Access Compliance Report Public Rights-of-Way (RR Crossings)

Intersection ID: 10025384	Main Street: E_9TH_ST	Location: N/A
ADA ID: B474314C8D79	Overall Compliance: No	Severity Score: 0.0
Codes/Mitigation Info/Possible Solution		Field Measurements/Component Compliance

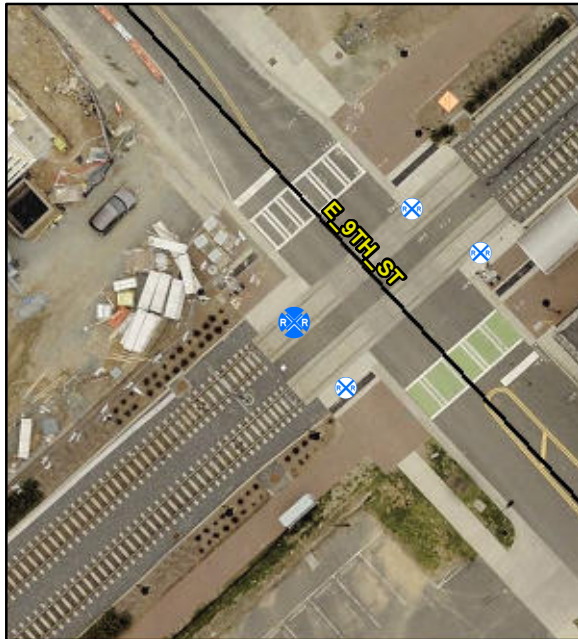
**Remove & Replace Detectable
Warning System. Provide Pedestrian
Gate. Remove & Replace Walking
Surface Adjacent to Rail.**

Compliance	Description	Data
Yes	DWS Provided?	Yes
Yes	DWS Contrast?	Yes
Yes	DWS Width (in)	Yes
Yes	DWS Length (in)	24.0
No	DWS Offset (in)	192.5
No	Pedestrian Gate?	No
N/A	DWS Outside Gate?	No
N/A	Rail Type?	LightRail
No	Flangeway Gap (in)	2.75
Yes	Sidewalk Width (in)	186.0
